Company	Trenz Electronic GmbH
PCN Number	AVN-20220429
Title	AVN-20220429 Problems with PCIe
Subject	Information and remedy concerning problematic with PCIe (SoC as Host)
Issue Date	2022-04-29

3.2 #2 Replace C93 and C94 by 00hm resistor

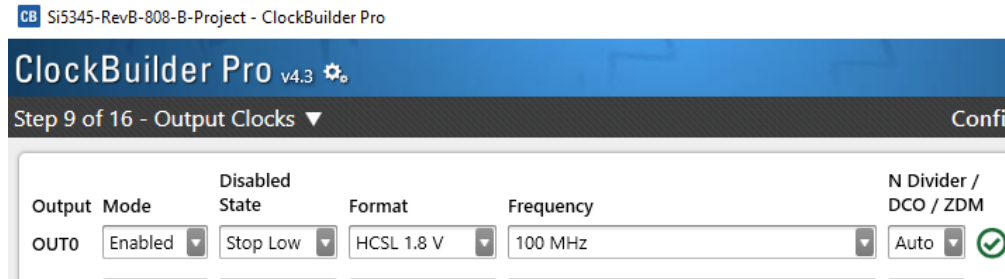
Reason: DC coupled HSCL standard is more in compliance with PCIe specification and will improve PCIe stability. Capacitor C93 and C94 of PCI_REF_*/CLK0_* should be replaced with 00hm resistor

Impact: Design which still use LVDS as PLL output for PCIe CLK to the carrier are recommended to be configured to use HSCL, see #1.

- #1: Check PLL project files of your design
TE0808/TE0807:

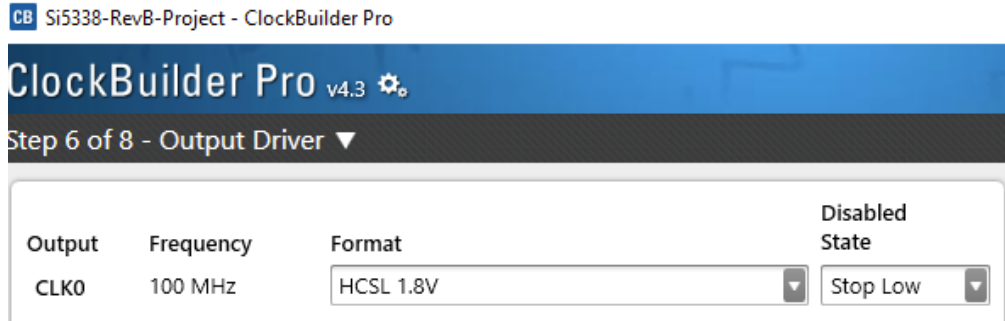
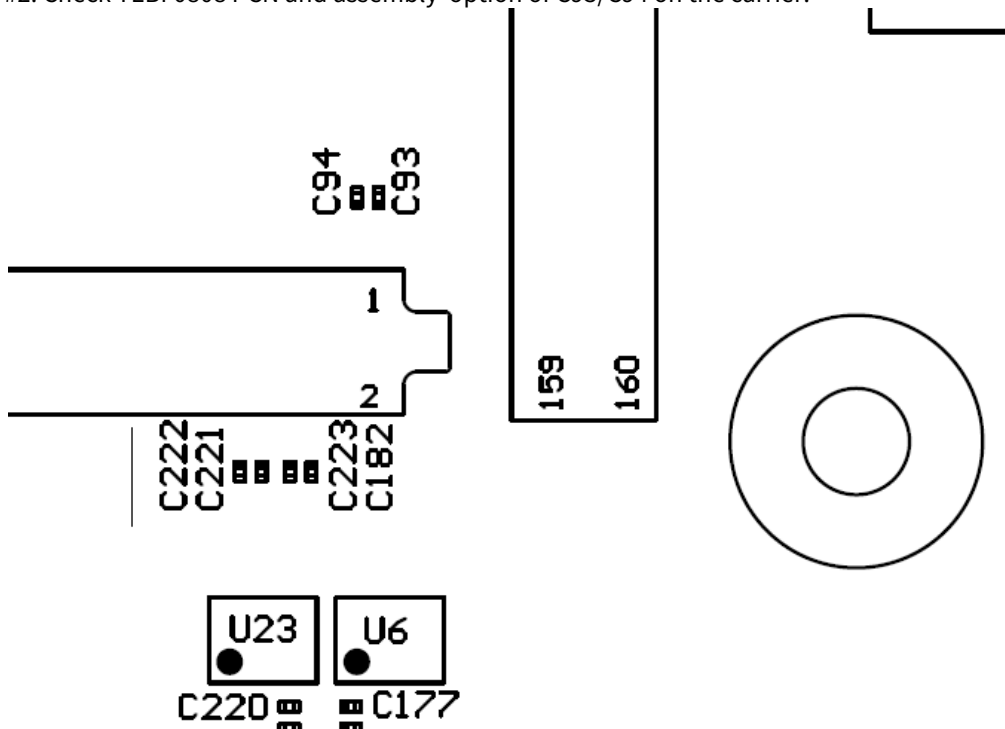
3.1 #1 Use HSCL standard for PCIe CLK

Reason: HSCL standard is more in compliance with PCIe specification and will improve PCIe stability.

Impact: Carrier which still use AC coupled reference CLK for PCIe on the carrier are recommended to be modify, see #2. Changes will be implemented in newer reference designs (2021.2 or newer)
